Product Change Description

[Z791G]
[ZTE Corporation]

[Z791]
[ZTE Corporation]

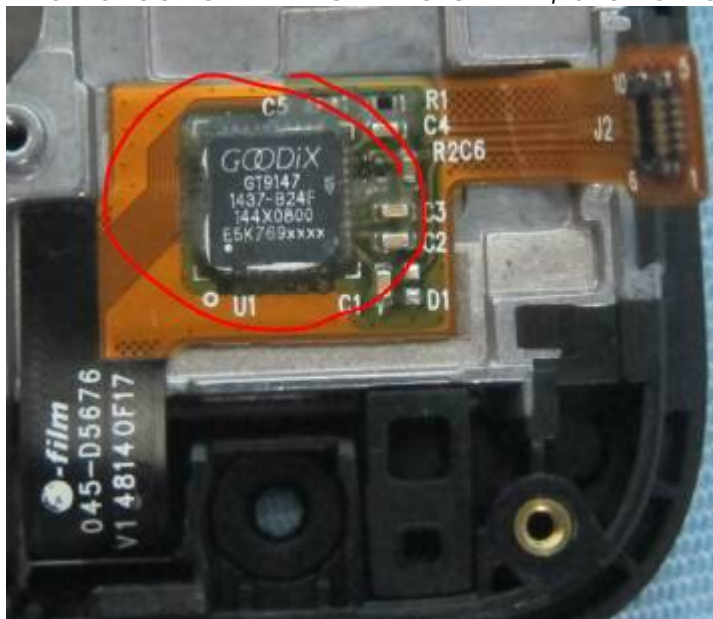
Other changes: Yes

The SIM card socket is changed from push-push type to push-pull type

The earphone jack is changed from 13.1X6.6X4.55mm to 8.7*12.66*4.2mm
